<b>To:</b>	All Plan Holders	<b>Project:</b>	Taxiway Reconfiguration Project
<b>Airport:</b>	San Angelo Regional Airport	<b>KSA Project No.:</b>	SAN.059
<b>Date:</b>	07/24/2017	<b>Client Project No.:</b>	AP-02-17

Addendum No. 2 Issued By:  
KSA

## SAN ANGELO REGIONAL AIRPORT TAXIWAY RECONFIGURATION PROJECT SAN ANGELO, TEXAS

**MARKING DEMO PLAN**  
**PAGE 1**

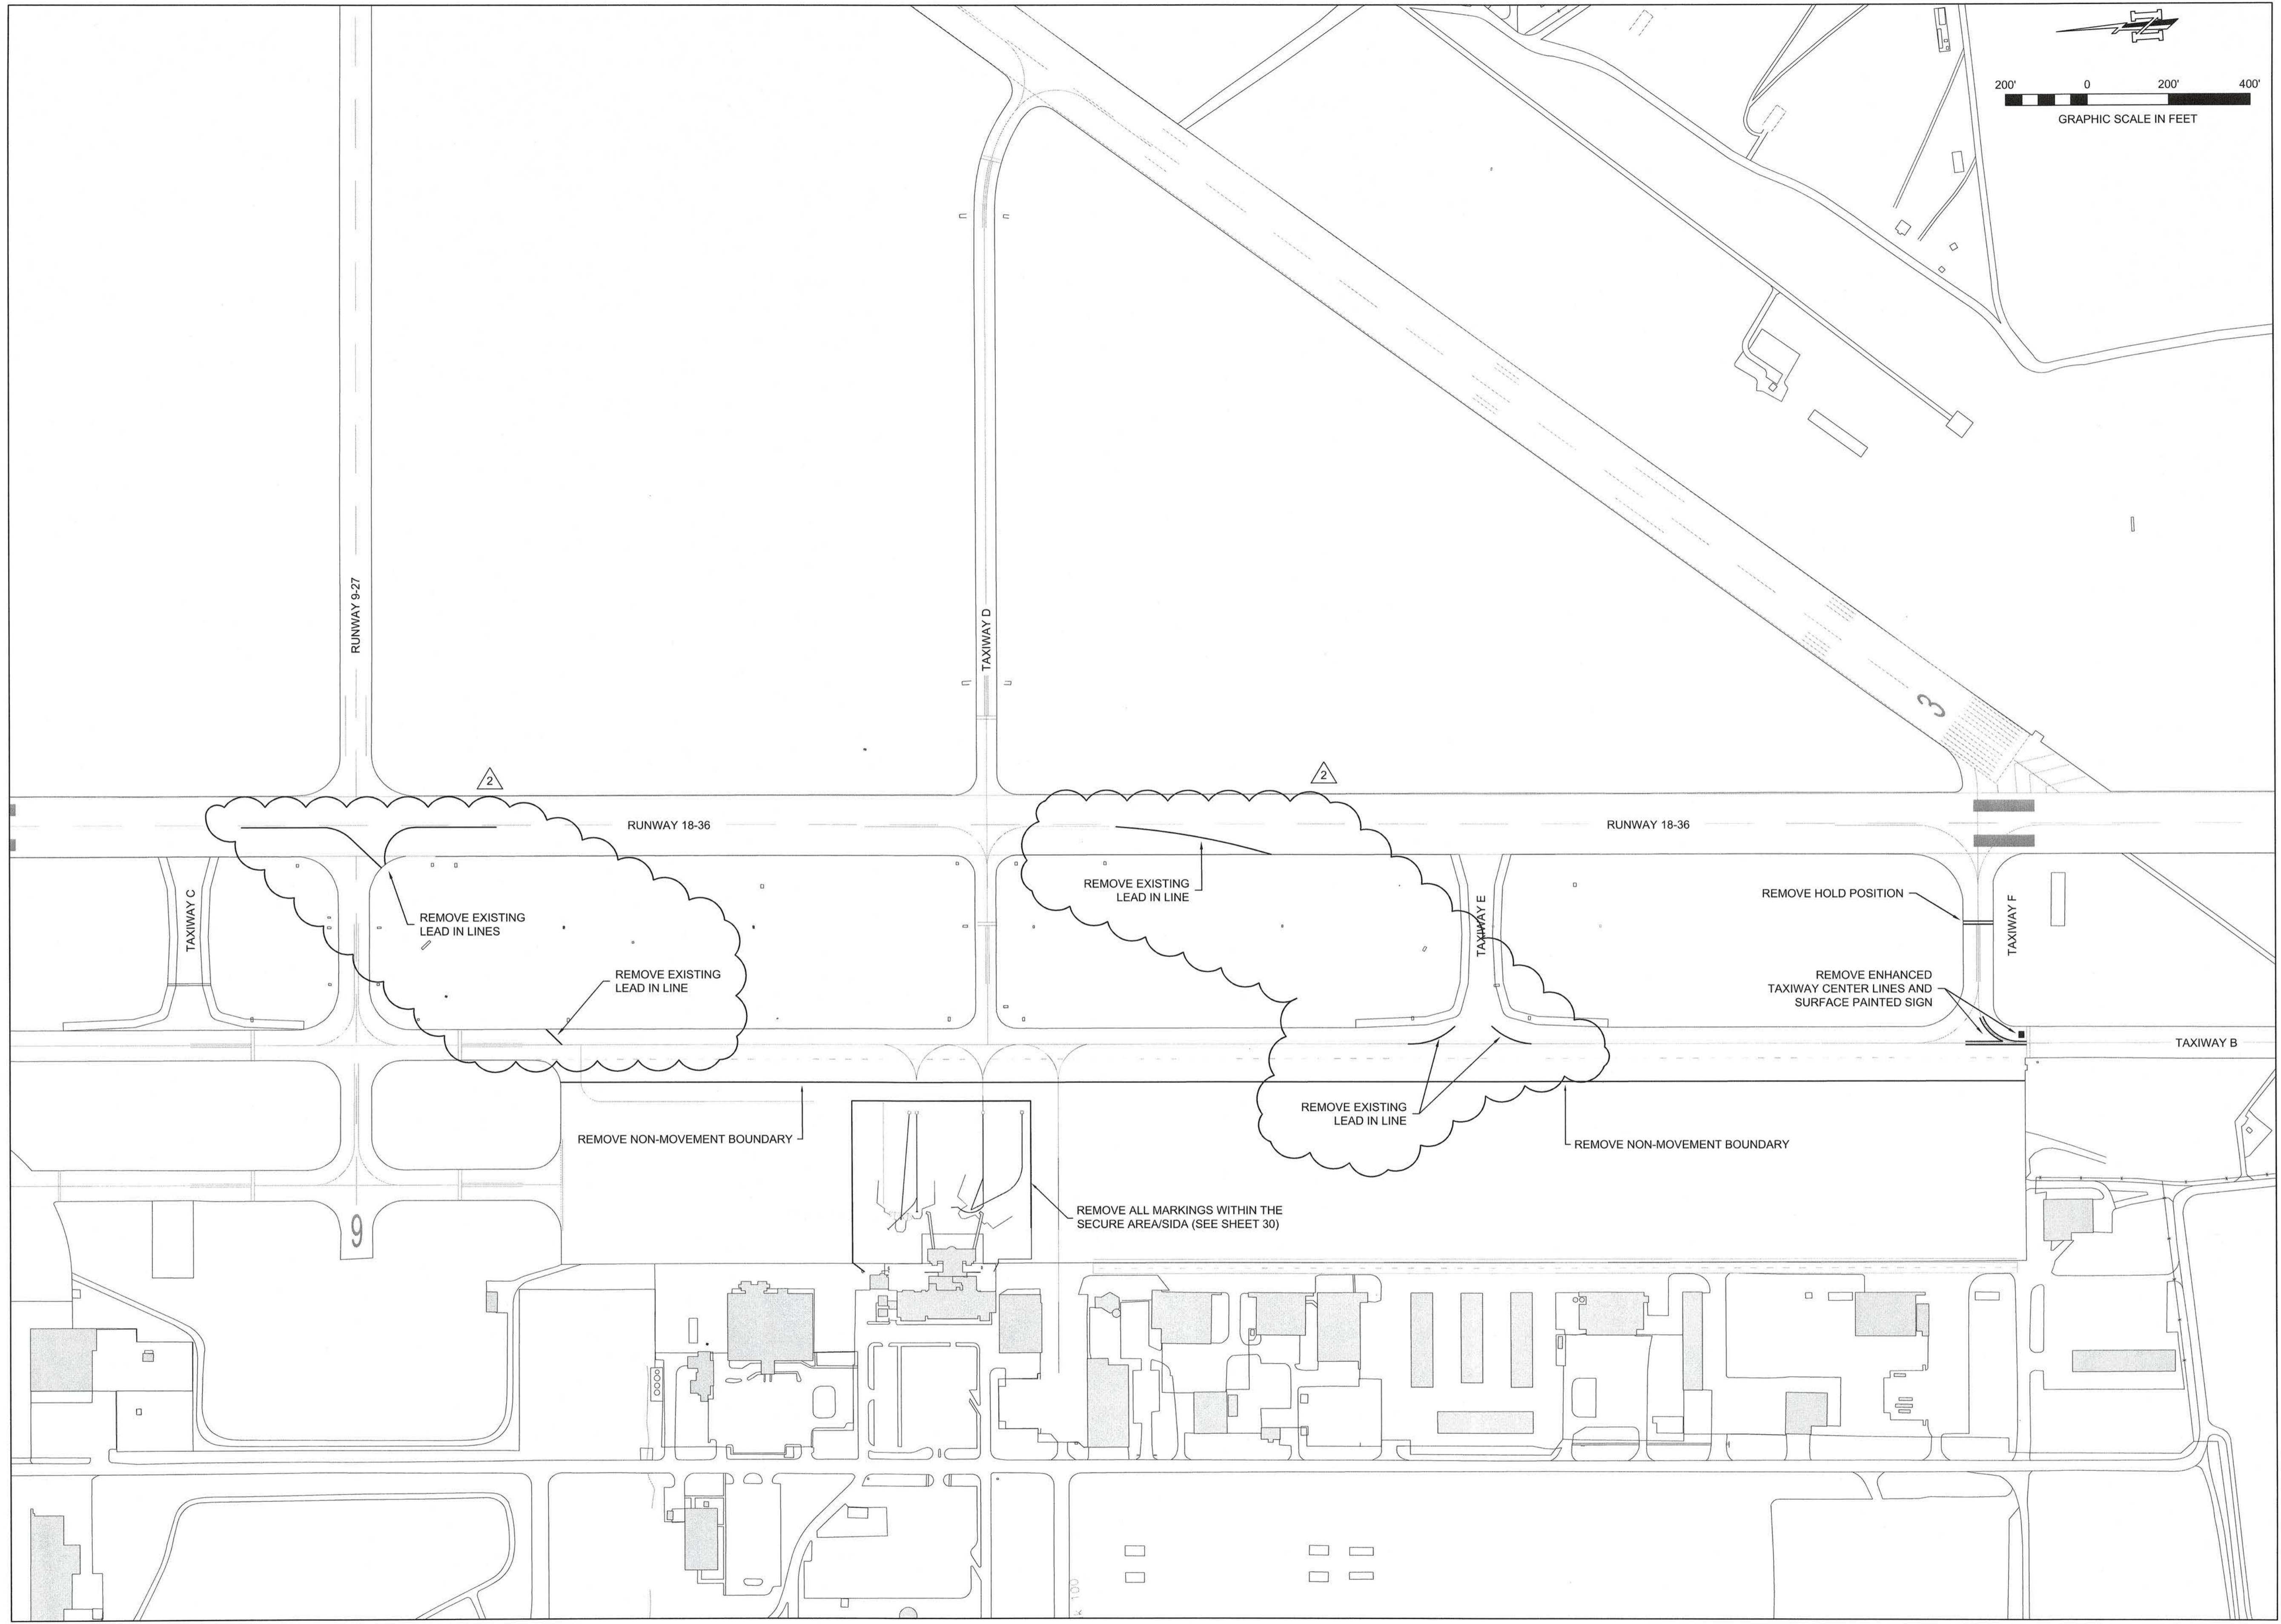
B. Plan Sheet 26, Marking Demo Plan Page 1

1. Replace with the attached Revised Plan Sheet 26, Marking Demo Plan Page 1
